Errata Sheet

Product Family: Terminator I/O Profibus DP Base Controller Manual
Manual Number T1H-PBC-M
Revision and Date 1st Ed., Rev. A; April 2004

Date: March 20, 2013

Pages 1-7. Introduction; T1H–Profibus Base Controller:

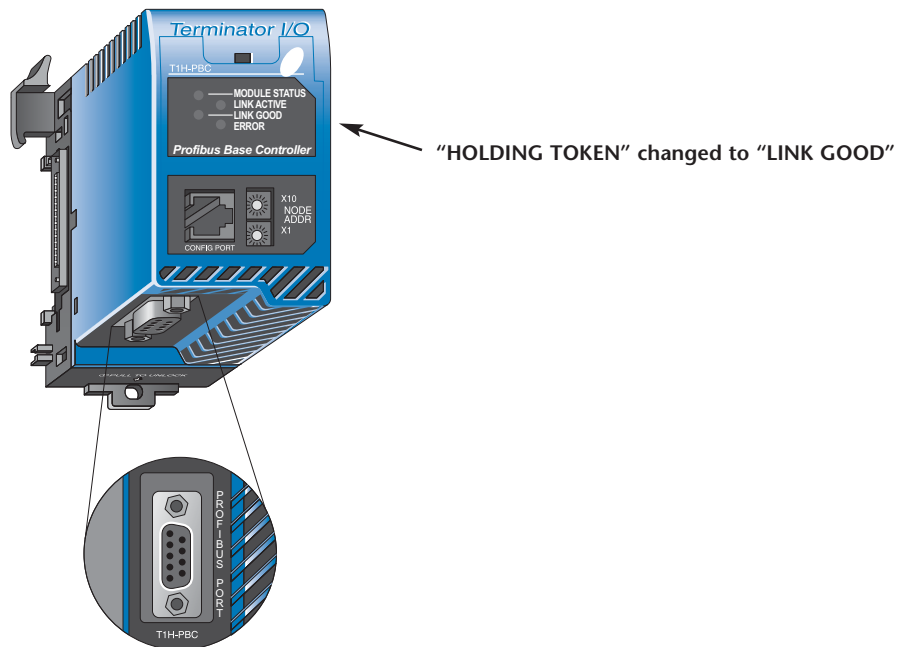
The T1H-PBC module faceplate changed. The status indicator named “HOLDING TOKEN” was changed to “LINK GOOD”. The status indicator function did not change.

Pages 1-6, 2-3, 2-4, and 2-5 all have drawings showing the old faceplate. “HOLDING TOKEN” is also referred to on pages 2-10 and A-2. Change all references to “HOLDING TOKEN” to “LINK GOOD”.

For example, replace the drawing on page 1-7 with this one:
